**Subject: Air Permitting Requirements for Increasing the Amount of Low Density Product
Made in the Ammonium Nitrate Prill Tower
Nitram, Inc, Tampa FL
FDEP Air Facility No. 057 0029**

AC Permit Issues – Discussion Points for District Air Staff
Current Status – Proposed Final Agency Action

This letter addresses the 10 questions in the FDEP SW District air section's October 23, 2001 Incompleteness Letter concerning Nitram's pending air construction permit application. The purpose of that application is to delete the low-density prill production rate limits from the relevant Title V permit conditions, and to make other related corrections and clarifications to the provisions of the current Title V air operation permit.

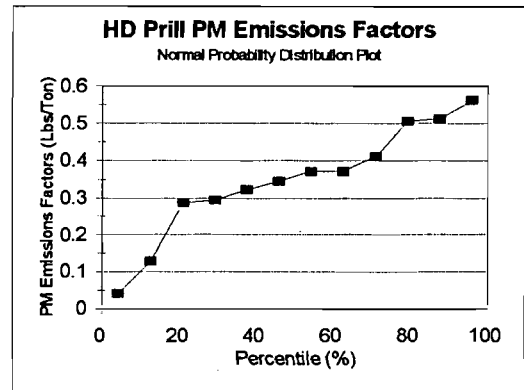
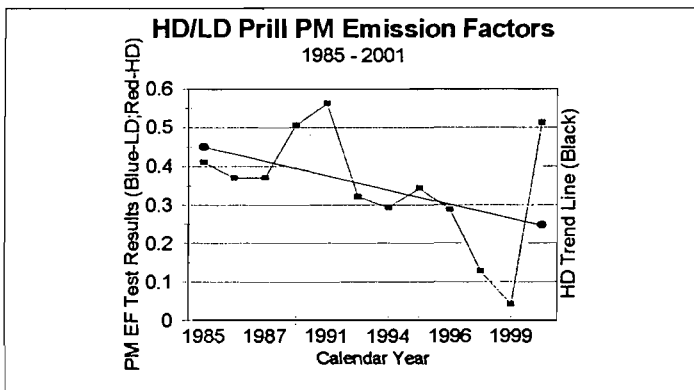
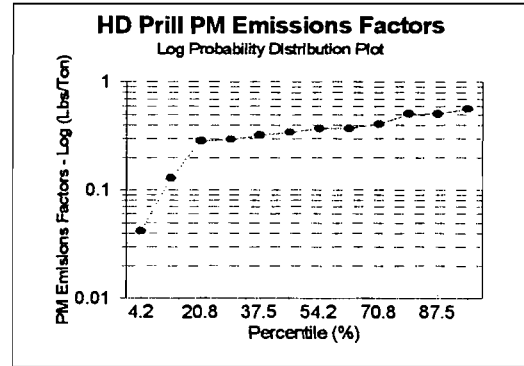
The first Data Analysis Sheet (TABLE 1 - NITRAM PRILL TOWER PM EMISSIONS TEST DATA: 1985 - 2001, High Density & Low Density Prill [Including the 1998-99 Low Test Values]) lists all of the available data for the unit (1985 - 2001): 12 tests for HD prill, and 2 tests for LD prill. The Probability Distribution Plots of the data (the two lower right graphs) shows that the 1998 & 1999 test results don't fit the normal distribution for the other 10 test results. That indicates that those two test results probably are significantly lower than the actual emissions rates during the test periods.

The apparent significant downward trend in the 12-tests data set becomes insignificant when the two questionable test results are removed. For the 10-test data set, the decrease in the trend line over a 16-year period is about 0.050 lb/ton. The standard error for the 10-test data set is 0.103 lb/ton. That indicates that the apparent downward trend in the data is not significant. It is within the "noise" of the normal variation in the values of the test results.

TABLE 2 - NITRAM PRILL TOWER PM EMISSIONS TEST DATA: 1985 -2001

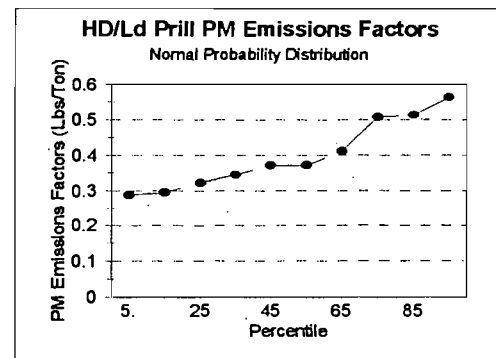
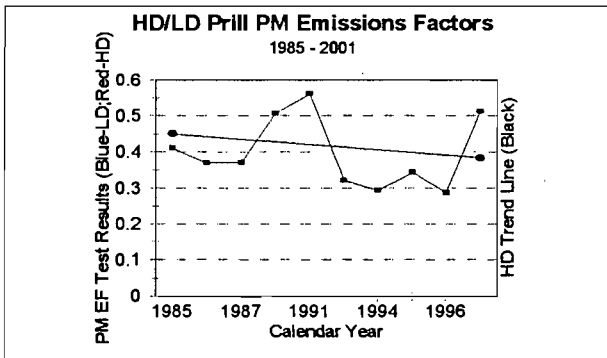
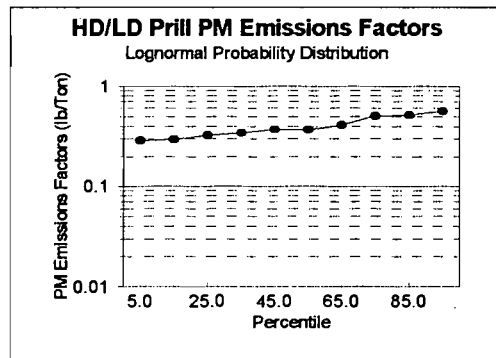
The second Data Analysis Sheet (TABLE 2 - NITRAM PRILL TOWER PM EMISSIONS TEST DATA: 1985 - 2001, High Density & Low Density Prill [Minus the 1998-99 Low Test Values]) lists all of the available data for the unit, except for the 1998 & 1999 tests (1985 - 2001): 10 tests for HD prill, and 2 tests for LD prill. The Probability Distribution Plots of that data (the two lower right graphs) shows that the other 10 test results do fit a common lognormal distribution. That indicates that those 10 tests probably are more representative of the actual emissions rates than the 12-test data set presented in the first Summary Sheet.

When the two unusually low test results are removed from the data set, and the standard error for the remaining data points is considered, the apparent downward trend in the test results disappears. There has been no statistically significant upward or downward trend in the data over the past 16 years. Although the time series plot of the 12-test data set on The Table 1 Analysis Sheet may appear to be very random, they are not inconsistent, except for the 1998-99 low values.

Figure 3a
Prilling Process
Nitram, Inc.
Tampa, Florida

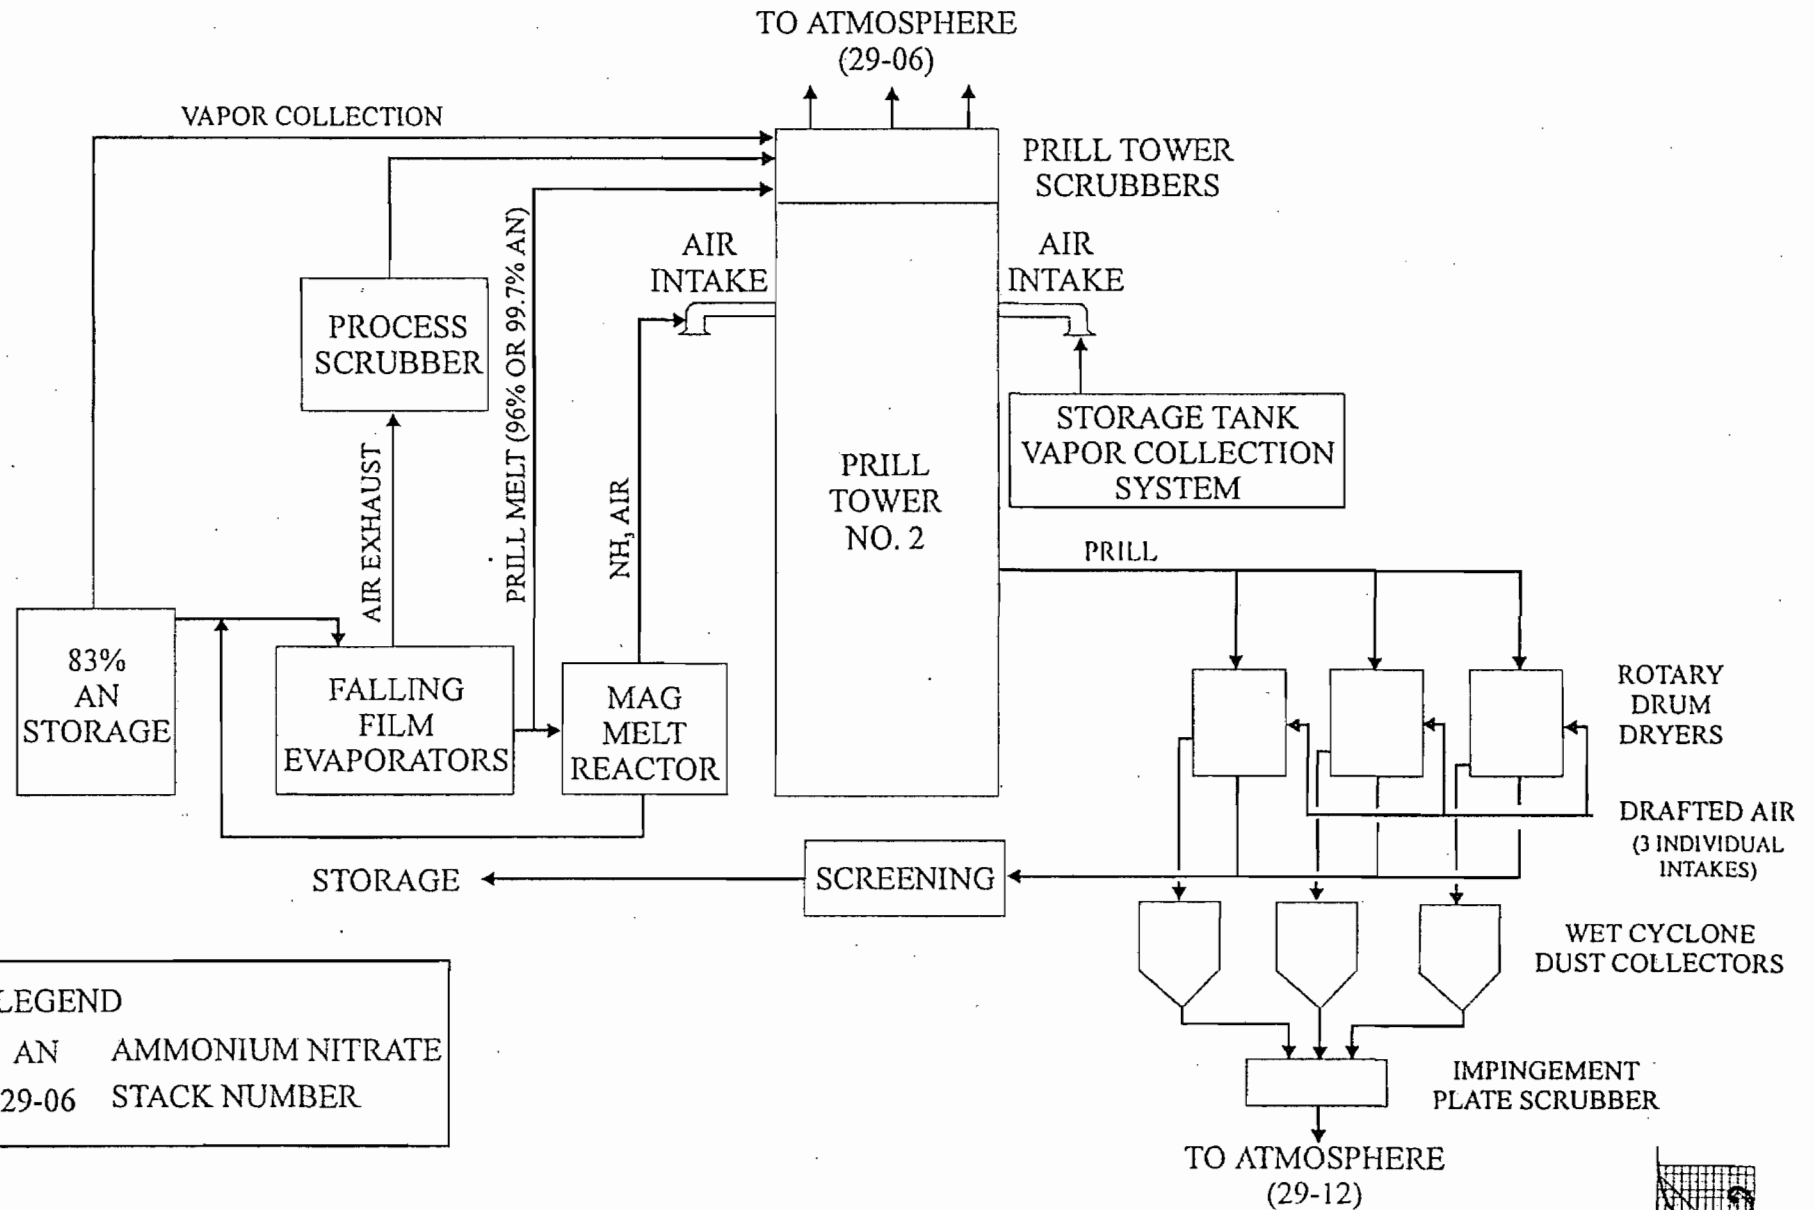
High-D only uses cooling drum and BX-304 & BX-306. Low-D uses everything as shown.
